Memorandum to the City of Markham Committee of Adjustment

File: A/118/22
Address: 5 Wildrose Crescent, Thornhill
Applicant: Kamran Naghavi
Agent: Brickhaus (Michael Shirzadfar)
Hearing Date: Wednesday December 7, 2022

The applicant is requesting relief from the following requirements “Third Density – Single Detached Residential (R3)” of By-law 1767, as amended, as it relates to a proposed second-storey and rear addition to the existing one-storey portion of the dwelling. The variances requested are to permit:

SECOND FLOOR PLAN

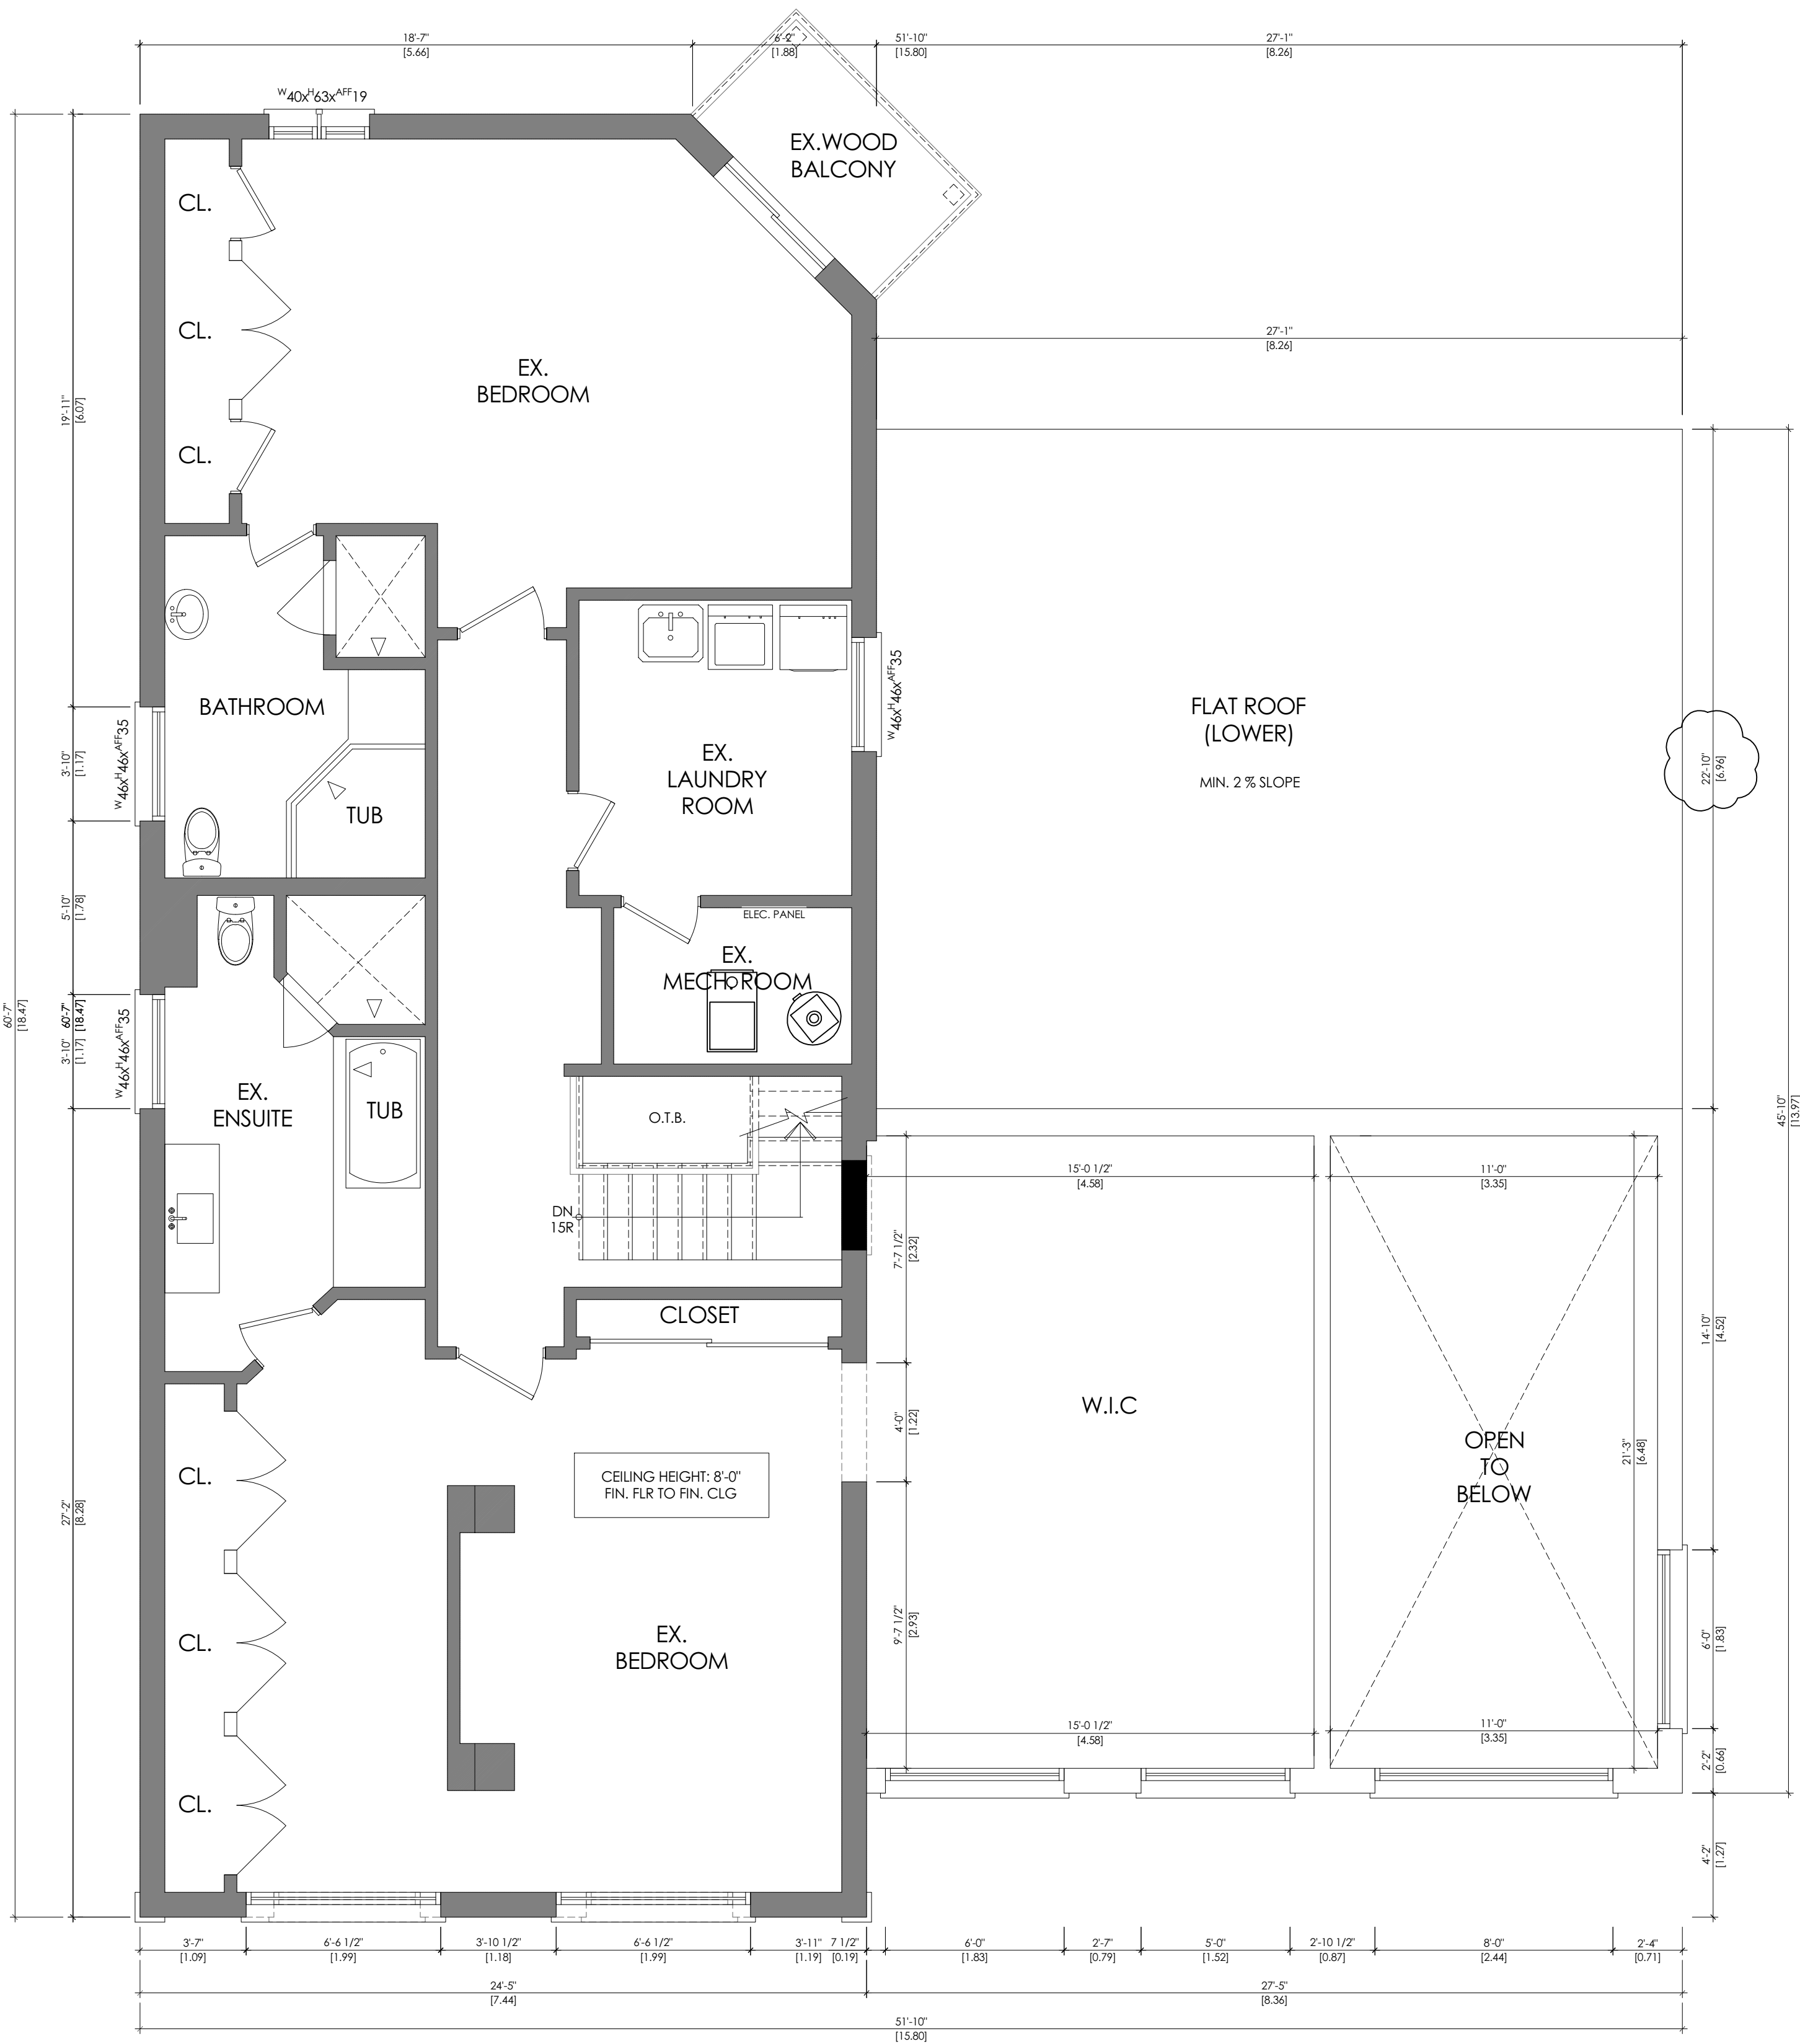
The applicant is requesting a minimum west side yard setback of 4.82 ft (1.47 m) for the two-storey portion of the dwelling, whereas the by-law requires a minimum side yard setback of 6 ft (1.83 m) for the two-storey portion of the dwelling.

The requested variance only applies to the two-storey portion of the building. The main floor complies with the minimum side yard setback requirement. Engineering staff have reviewed the application and have no concern with the variance with respect to drainage.

Staff have no objections to the requested variances, and are of the opinion that the general intent and purpose of the Zoning By-law is maintained.
